ZTE CORPORATION**Product Change Description**

[MF97B_T]

[MF97B]

[Project Number: 14ZTE147]

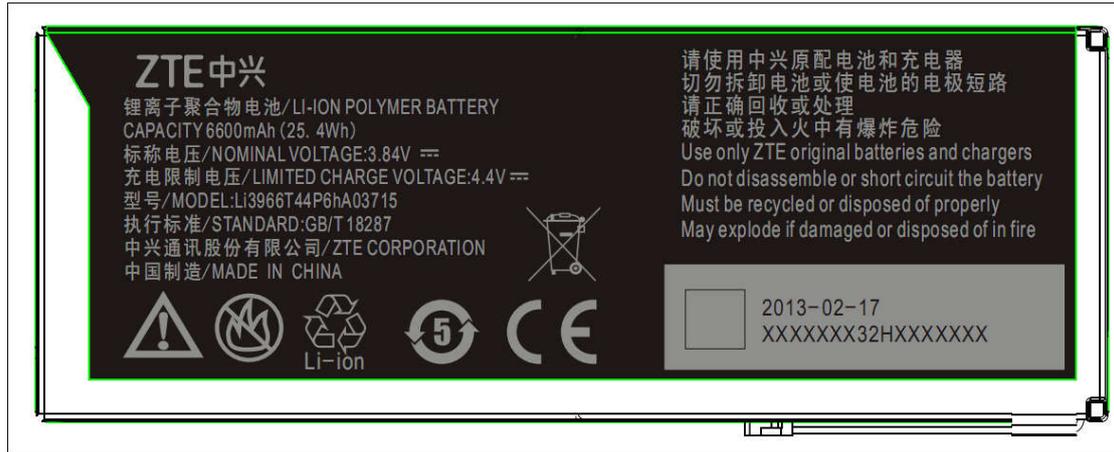
Battery changes: **YES, new battery.**

Please refer to below photo.

Original

Updated
